CWP INLET SOLENOID INFORMATION

This tech note details the evolution of the CWP inlet valve. The new Burkert 5282 series valve (P/N W2T915479) was incorporated in the CWP (starting with serial number 1339310) for its durability when energized open for extended periods. This new valve performs best when placed after flow meter F1 in the inlet assembly flow path, see appendix.

Pictures for Identification:

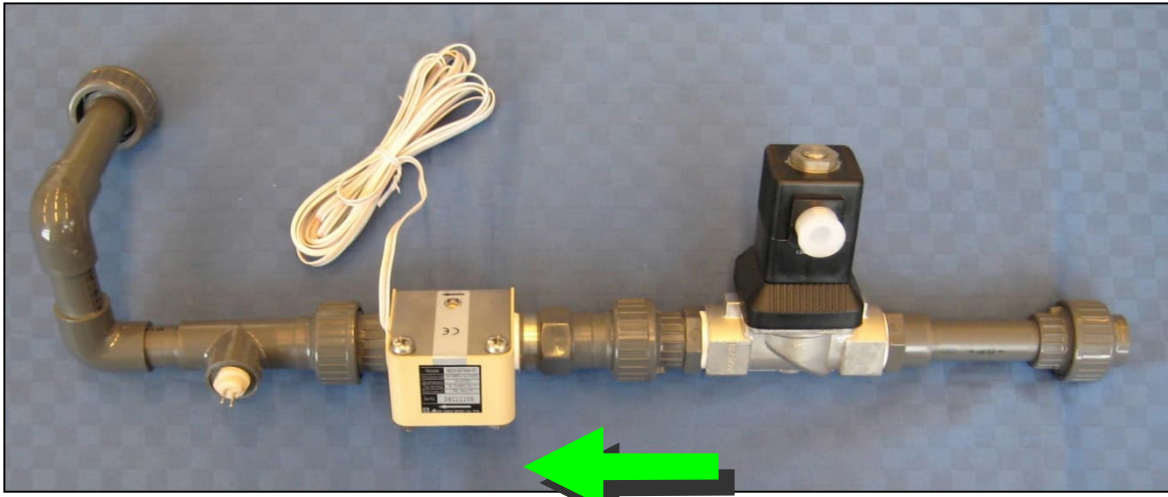
When upgrading to the new valve, we recommend replacing the PVC Inlet Assembly as described in this Tech Note. See the photos below for a comparison of the new Burkert 5282 series valve, its predecessor the 8W Burkert 6213 series valve, and its predecessor the 18W Burkert 6213 series valve.

New Burkert 5282 inlet solenoid valve with 8W coil

Previous inlet solenoid valve, Burkert 6213 with 8W coil

Old inlet solenoid valve, Burkert 6213 with 18W coil

Appendix

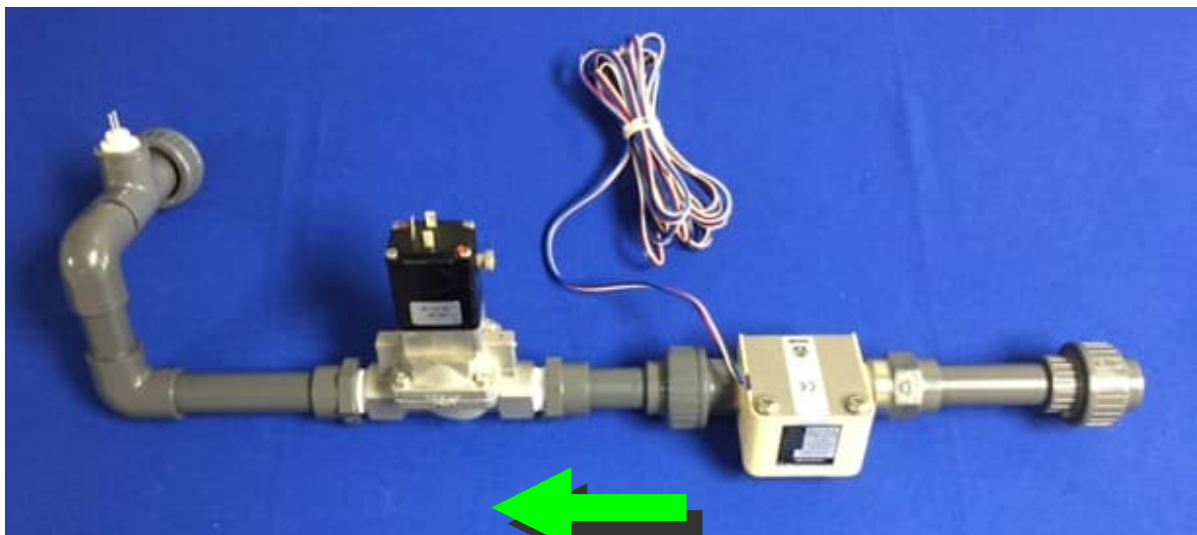
The figure above shows the previous PVC Inlet Assembly configuration on CWPs built up to S/N 1342550. Note the inlet valve is before flow meter F1 in the flow path. The inlet valve depicted in this figure is the Burkert 6213 series with 18W coil.

The figure above shows the new PVC Inlet Assembly configuration on CWPs built from 1342551. Note the inlet valve is after flow meter F1 in the flow path. The new Burkert 5282 series valve is shown in this assembly. The manual bypass switch standard on this valve series can be seen protruding from the right side of the valve coil.

The new Burkert 5282 series inlet solenoid valve was introduced in production starting with S/N 1339310 for CWP 101-106H/S. For optimal performance, the PVC Inlet Assembly was reconfigured (starting with S/N 1342551) so that flow meter F1 is before the valve in the flow path. All units manufactured by MCP now use this valve.
